Proposal of pin assignment for the bias voltages in the interface connector between the module and the power/DAT cable

T. Kohriki, T. Kondo, S. Terada, Y. Unno
Institute of Particle and Nuclear Studies
High Energy Accelerator Organization (KEK)
Oho 1-1, Tsukuba, Ibaraki 305, Japan

KEK971017TK

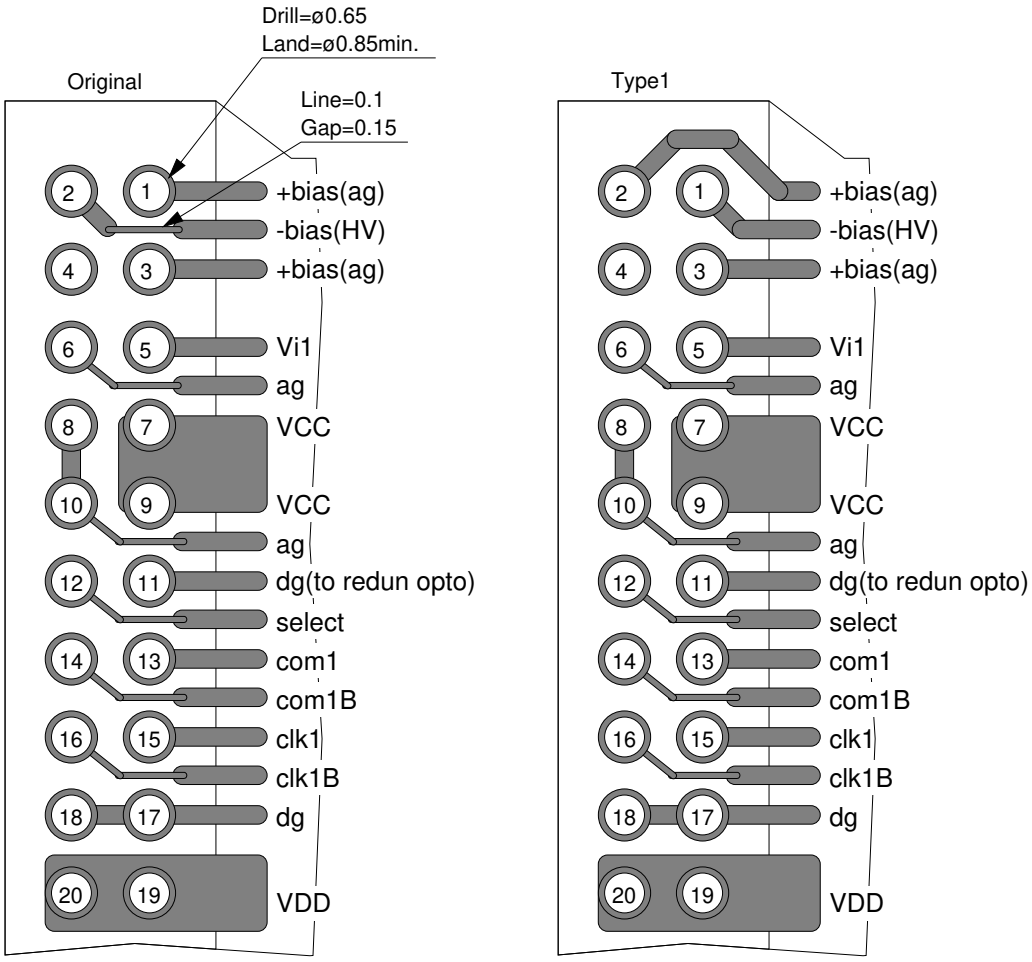
In the original assignment , the negative bias high voltage was assigned to Pin#2. The positive bias (analog ground level) being assigned to Pins#1 and #3, and in case when the negative bias shall go in the same layer, it must go through the gap of Pins#1 and #3. This might be too tight for the high voltage such as 500 volts. The situation is true as long as we use the through-hole-pin type connector even if the negative bias line is in the different layer.

The proposed new pin assignment is the "Type1" in the drawing. The assignment of voltage to the Pin#1 and #2 is swapped and this swapping is only internal in the connector; no swapping in the traces.
